OWNER 	BUSHEHR PETROCHEMICAL COMPANY MEG PLANT						EPC CONTRACTOR:  Chagalesh-Enerchimi-Steam Joint Venture BUPC-MEG PLANT PROJECT		
	Architecture diagram for reciprocating compressor								
MC :  شرکت سفت و سوی توسعه ایرانلیان							Project	Area	Phase
Owner Document Number: 17811-46	BU	20	VD	303	IN	DIG	0044	Rev.:	Page
								00	1 of 3

## Architecture diagram for reciprocating compressor

شرکت پتروشیمی اوشهر	 Chagalesh-Enerchimi-Steam Joint Venture BUPC-MEG PLANT PROJECT	BUSHEHR PETROCHEMICAL COMPANY MEG PLANT
<b>Document Review</b>		
Issue Purpose:	FA	
Result Code: AP,AN,CM,RE,NC	CM	
Next Status : IFC,IFA,IFI,AFC,AB	IFA	
Responsible Department	MECHANICAL	
Commented Date	May.05.2021	
<b>Approval or review hereunder shall not be construed to relieve Vendor / Subcontractor of his responsibilities and liability under the contract.</b>

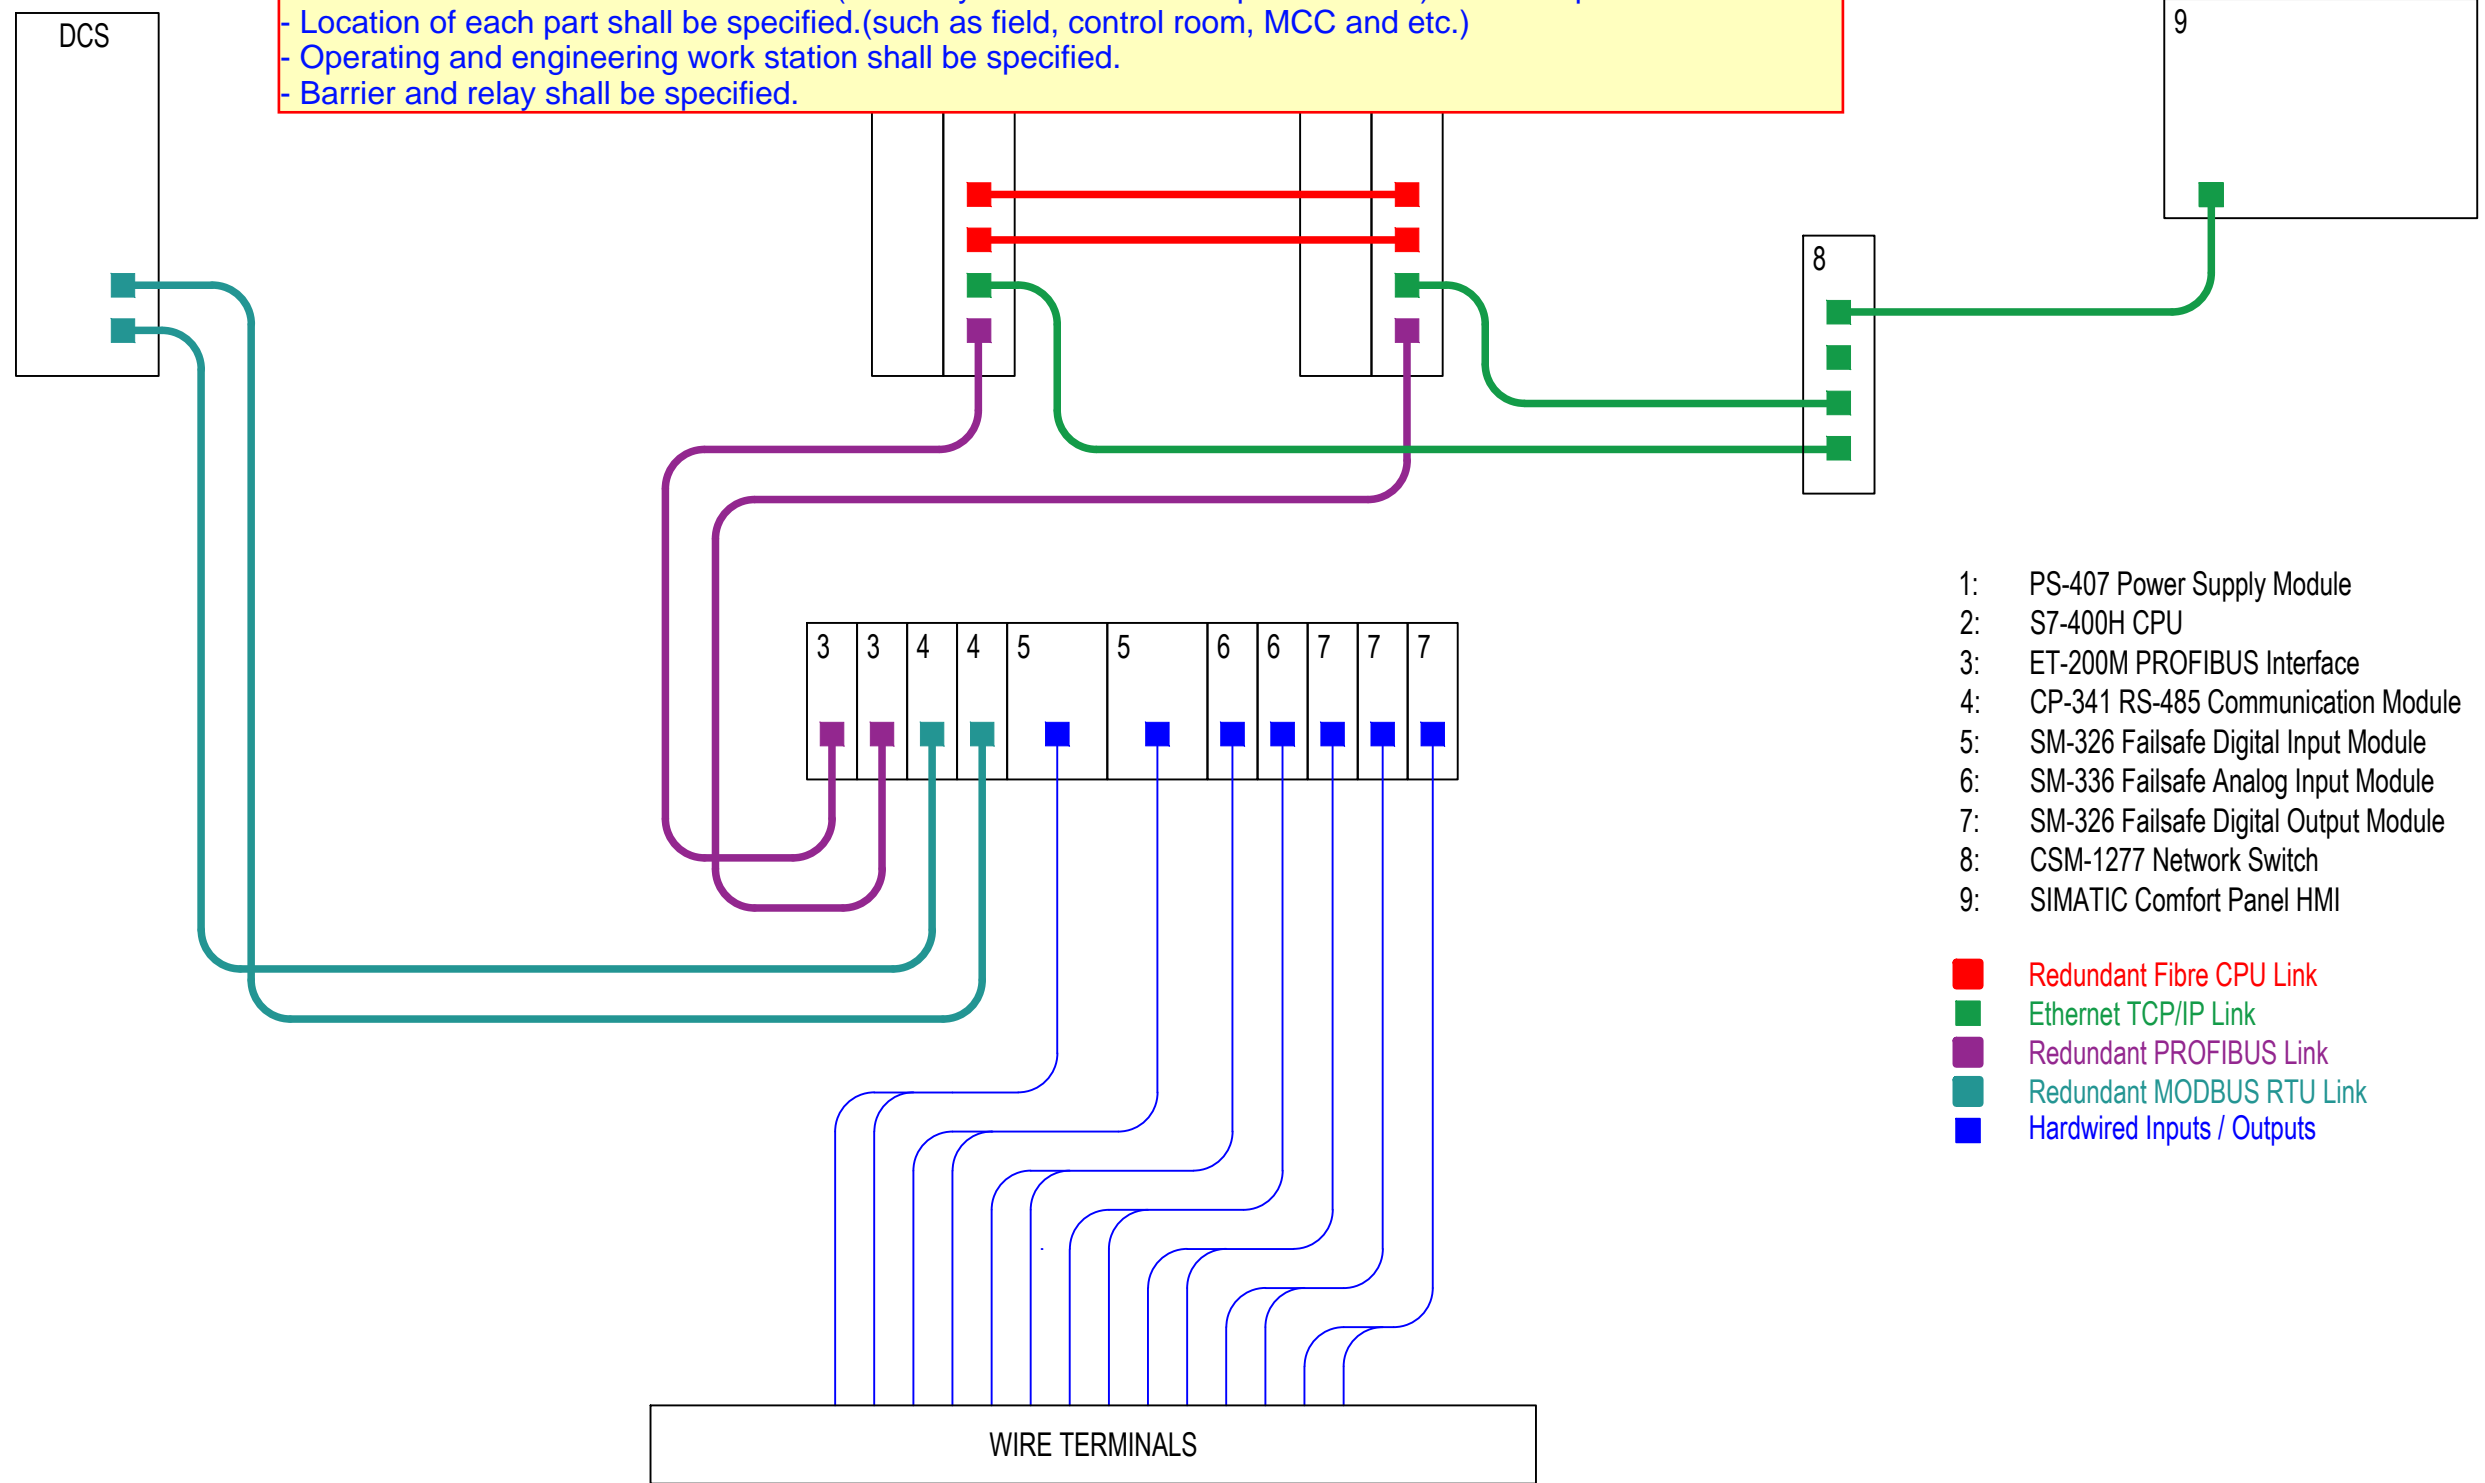
This document is checked only for compressor 7080. New document should be generated for compressor 1002.

- This architecture is not clear and acceptable it shall be revised according to attached file.  
 - Connection between UCP and ESD, FCS, MCC and JB's shall be specified.  
 - All interconnection between this PKG (internally between different parts of PKG) shall be specified.  
 - Location of each part shall be specified.(such as field, control room, MCC and etc.)  
 - Operating and engineering work station shall be specified.  
 - Barrier and relay shall be specified.
